# TOWN OF LOS GATOS

**PLAN CHECK COMMENTS**

**SCOPE OF WORK**  
• INTERIOR TENANT IMPROVEMENT (E) FOOD SERVICE REST.  
- DEMOLISH EXISTING FOOD SERVICE FACILITY  
- REPLACE MEZZANINE FLOOR  
- UPGRADE (E) FACILITIES TO COMPLY W/ HEALTH DEPT.  
- NO STRUCTURAL CHANGE - NO LIGHTING CHANGE W/ DINING RM  
• APPLICABLE CODES  
UPC, UMC, UPC 1994, NEC 1993  
ENERGY STANDARD 1995  
ACCESSIBILITY STANDARD  
CITY OF LOS GATOS REGULATIONS  
E-CODES.

PROPOSED TENANT IMPROVEMENT 151 N. SANTA CRUZ LOS GATOS - CA

Date	9.20.18
Scale	
Drawn	
Job	1809
Sheet	5
of

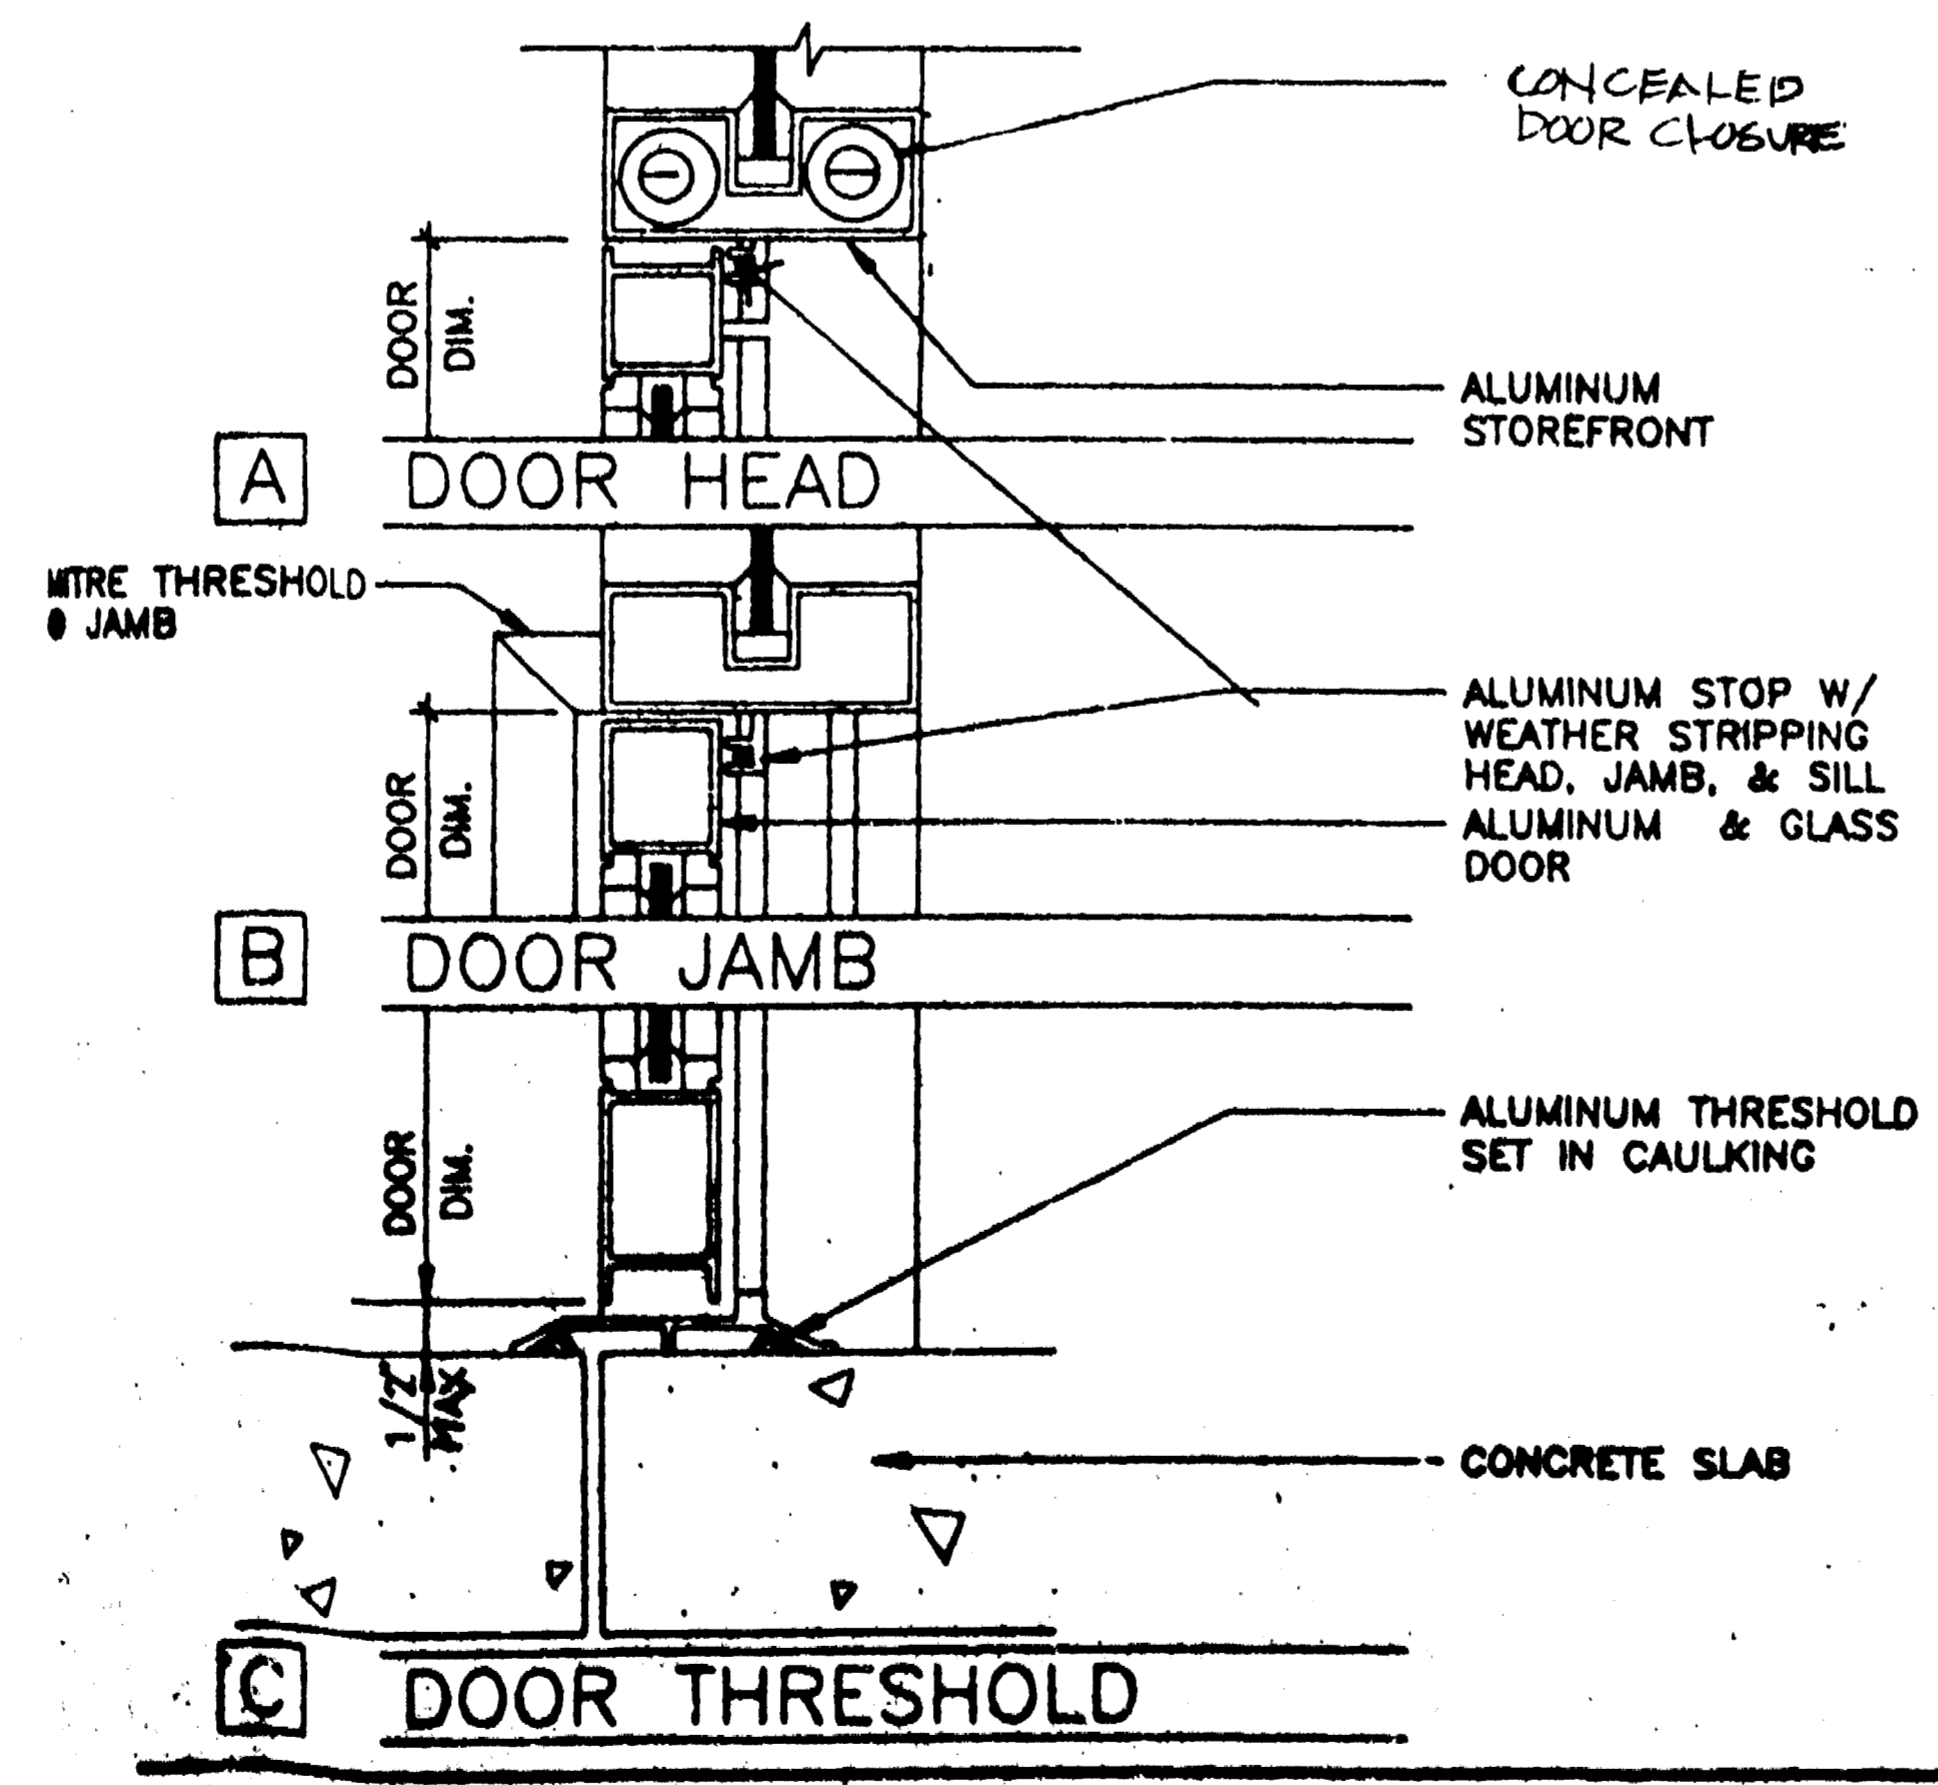
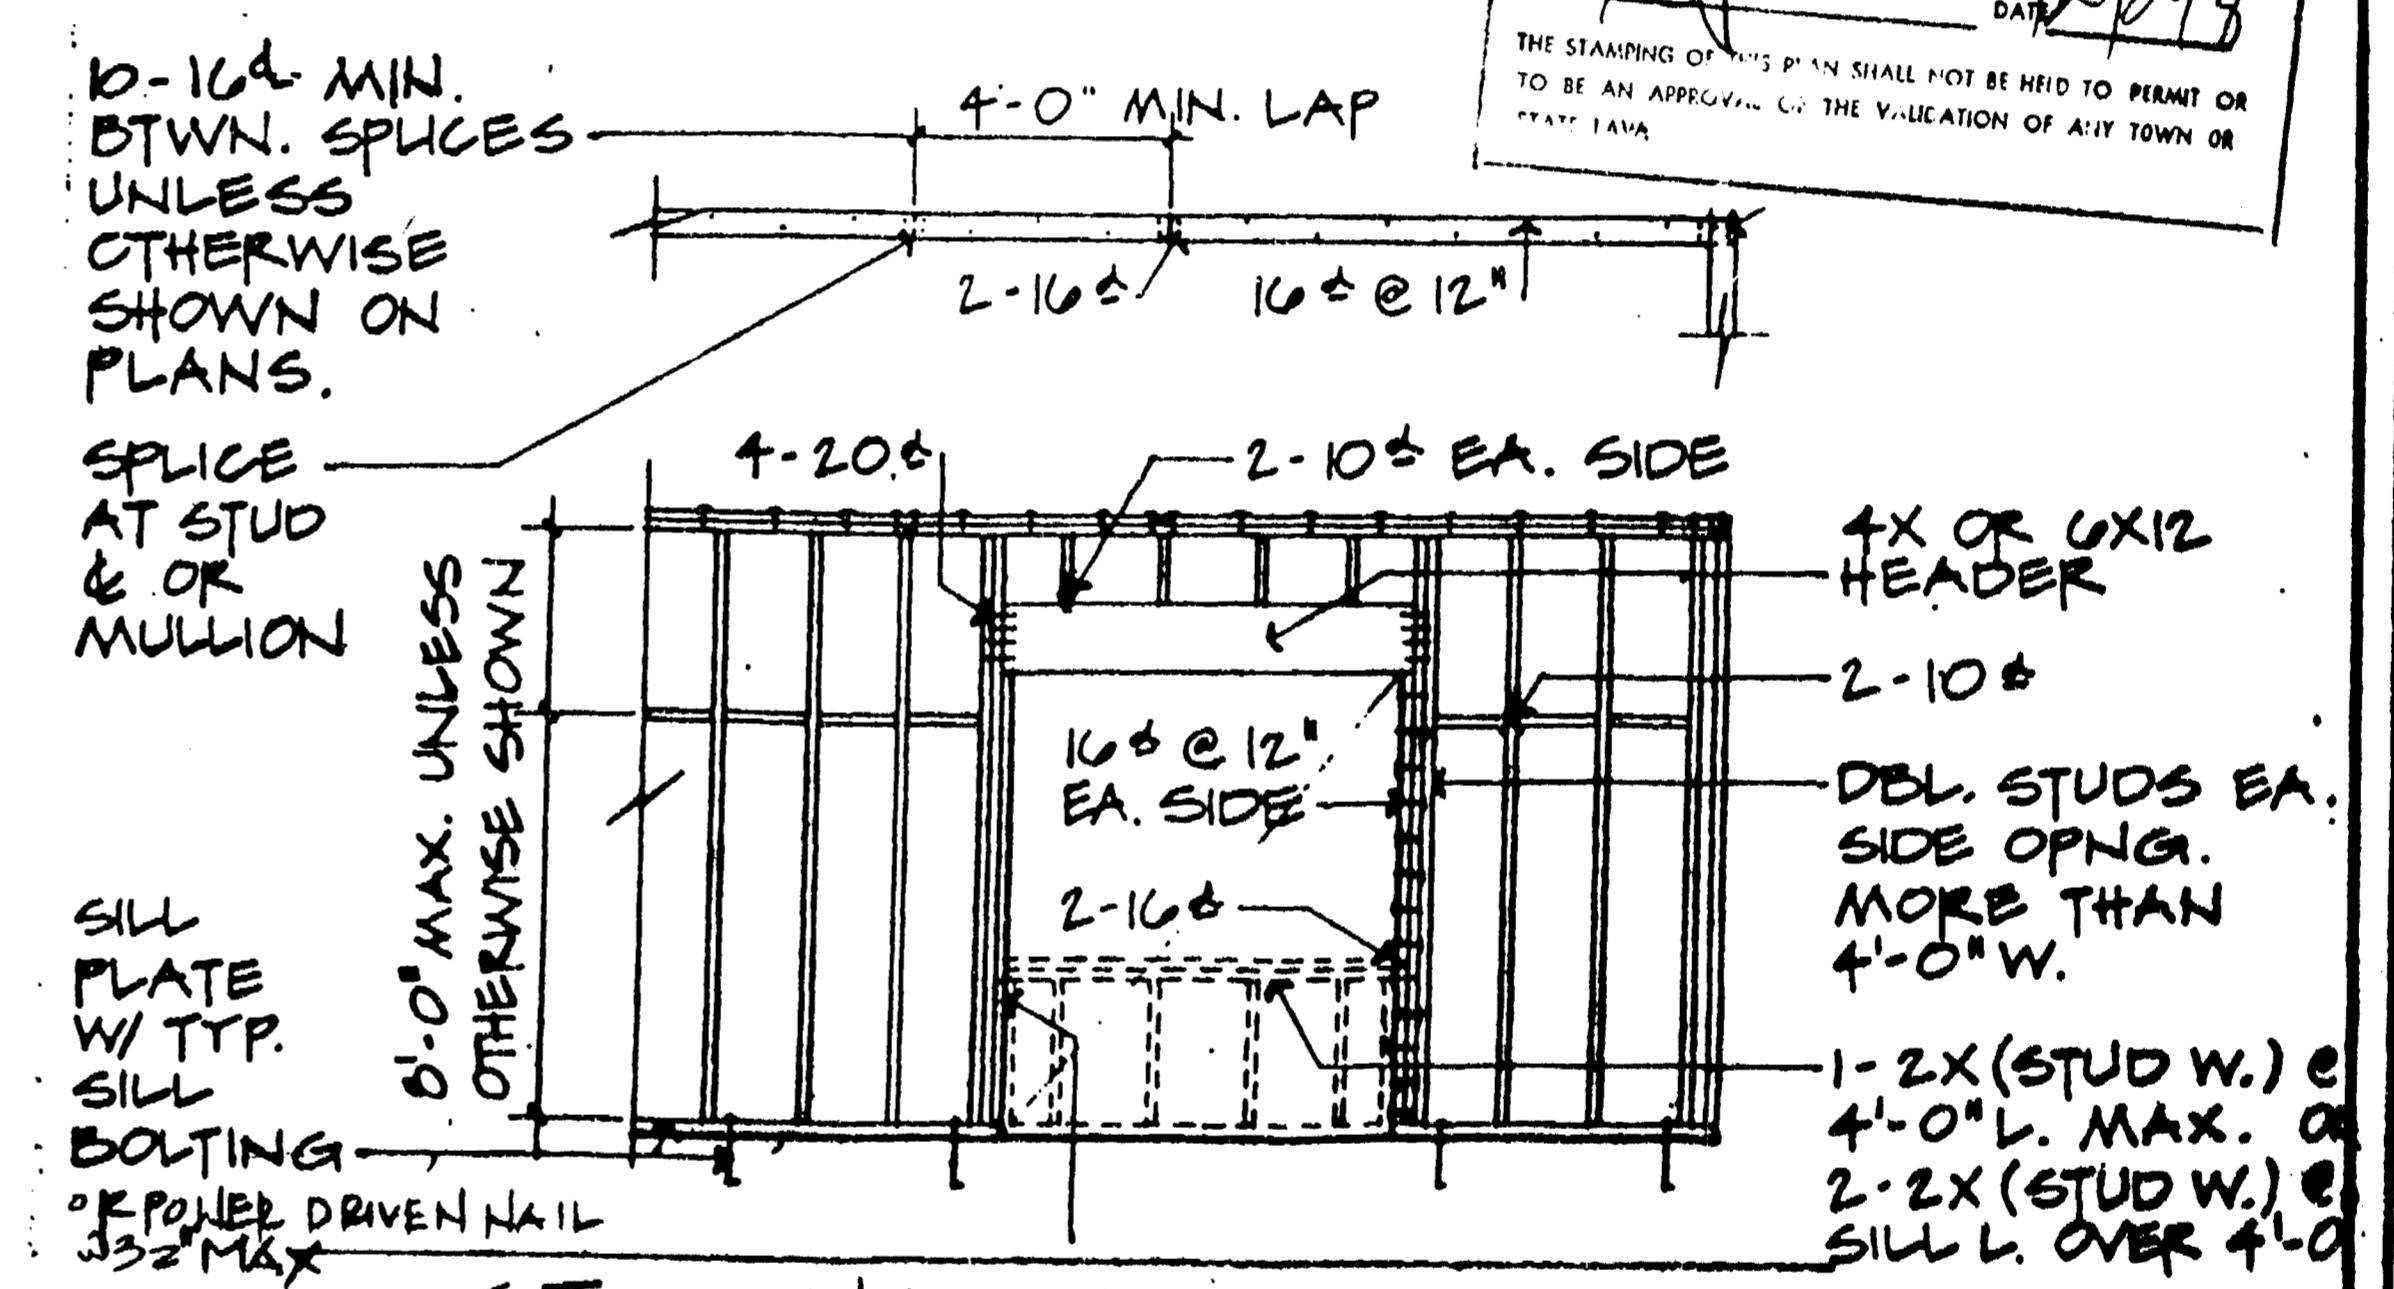
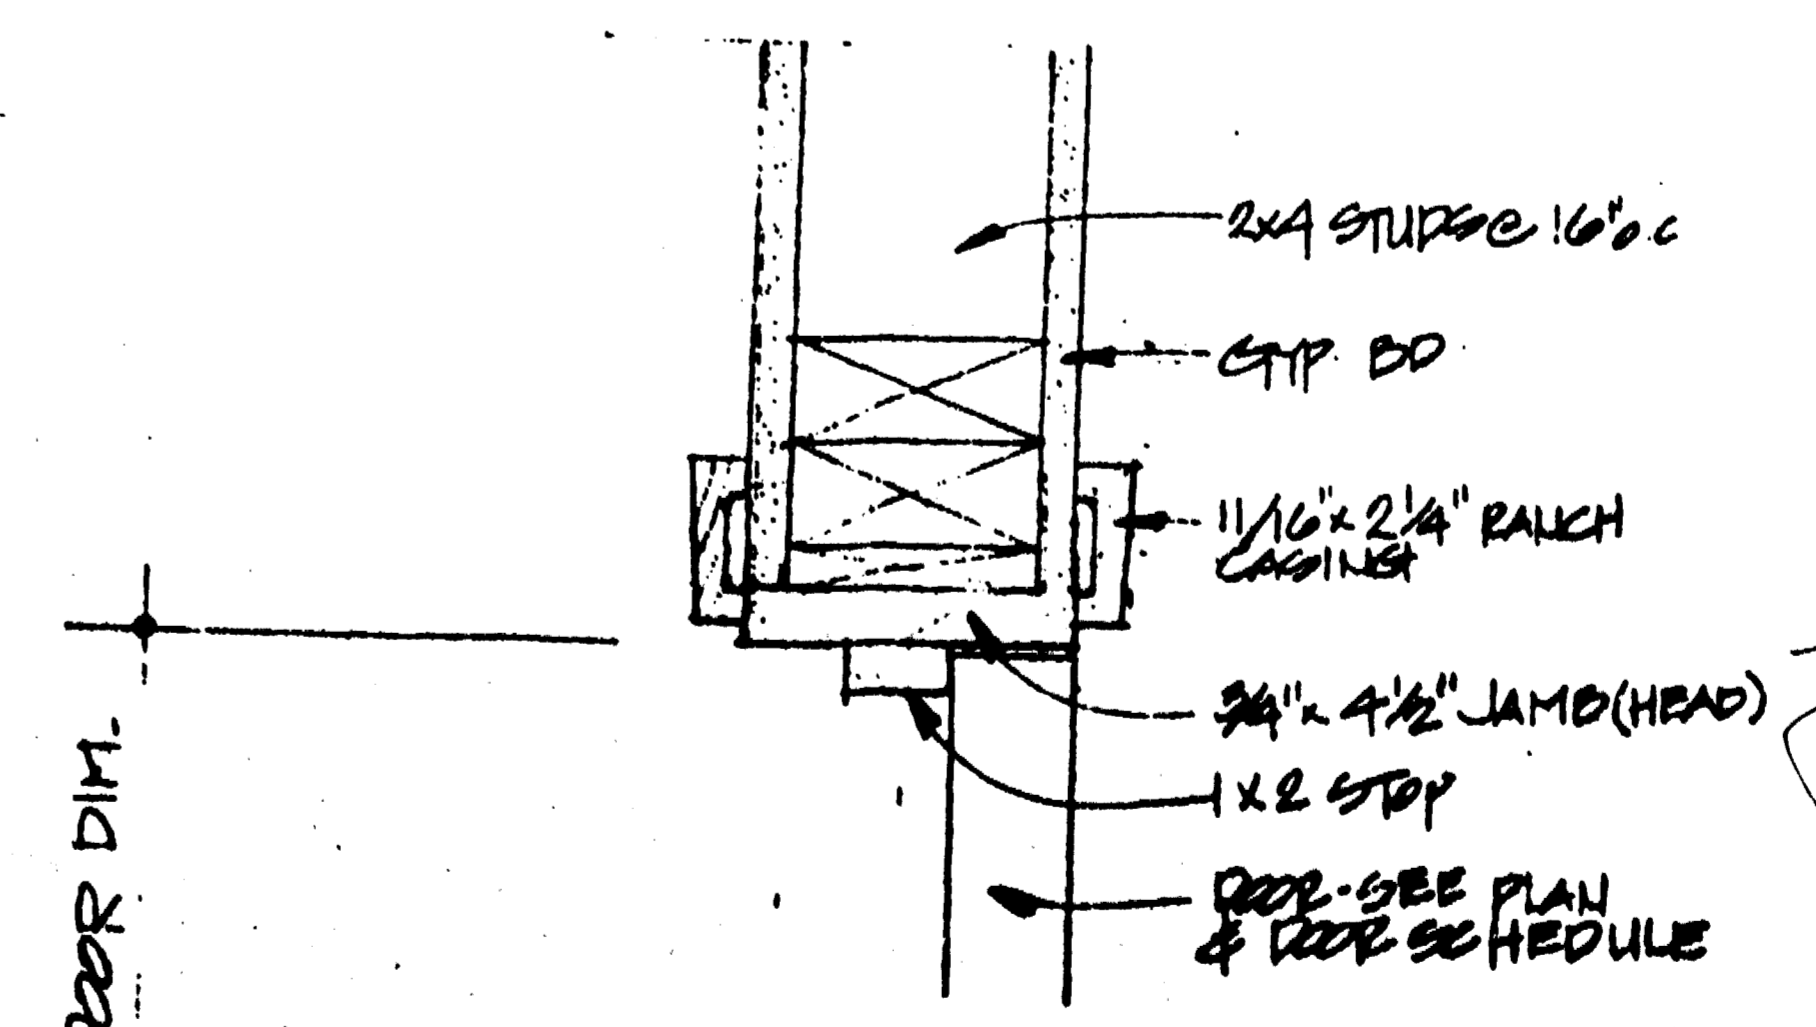
11. Revise the stair sections detail on sheet 3 to show 1-1/2" clearance between the handrail and the wall, as required per CBC Section 1006.9.2.5a.
12. Revise the plans to show how to provide striping for the visually impaired at the stairway, as required per CBC Section 1006.9.1.

13. Revise the door hardware detail on sheet 5 and the storefront detail on sheet 12 to show 60" from the ground surface to the centerline of the accessibility sign (not 48"), as required per CBC Section 1127B.3.

14. Note on the door threshold detail that the change in level between 1/4" and 1/2" is beveled at a gradient of 1:2, as required per CBC Section 1004.9.1a.

1. SHEET 7 - 12
2. SHEET 1
3. SHEET 2
4. SHEET 2
5. SHEET 2
6. SHEET 2
7. SHEET 2
8. SHEET 2
9. SHEET 2
10. SHEET 2-4
11. SHEET 5
12. SHEET 5
13. SHEET 5
14. SHEET 5 / SHEET 12
15. SHEET 5 / SHEET 12
